Work Order ID 135666***135666***

Item Name: Replacement Skidtube (Fits LH or RH)

DRAWING NO. D2650	TITLE 206/407 SKIDTUBE ASSEMBLIES	REV. F	DART AEROSPACE LTD ENGINEERING ORDER		D.E.O. NO. D2650-F-1	SHEET NO. SHEET 1 OF 1	SCALE NTS
DRAWN <i>JP</i>	CHECKED <i>A.P.</i>	MFG. APPR. <i>AA</i>	APPROVED <i>HH</i>		DE APPR. <i>HH</i>		
DATE 12.10.12	DATE 12.10.22	DATE 12.10.22	DATE 12.10.22		DATE 12.10.22

CHANGE C'BORED WELDED CROSSBOLT SPACERS TO SWAGED SPACERS

DETAIL G

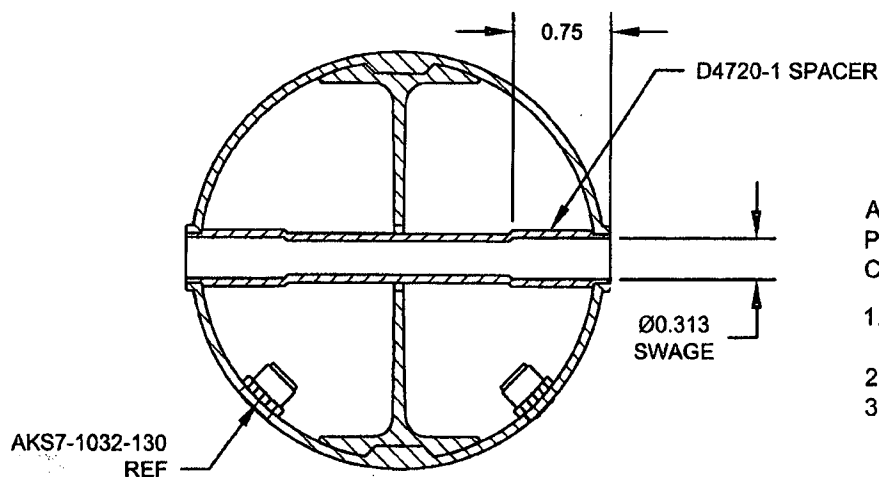
ADD DETAIL G BELOW, WHICH IS THE SAME SECTION VIEW AS DETAIL D OF DWG.

C'BORED HOLES ARE **NOW SWAGED** PER DETAIL G BELOW. FOR THE Ø0.375 HOLE THAT IS NOT C'BORED, WELD PER DETAIL D OF DWG (SEE AMENDED DETAIL B FOR REFERENCE).

AFTER DRILLING AND BENDING ASSEMBLY
PERFORM THE FOLLOWING FOR Ø0.375 HOLES THAT ARE
CURRENTLY C'BORED:

1. INSERT D4720-1 SPACER, 16 PL (-1) OR 17 PL (-3)
OR 19 PL (-5) OR 23 PL (-7)
2. SWAGE TO Ø0.313 X 0.75 DP PER QSI 002
3. TRIM / GRIND FLUSH PER QSI 002
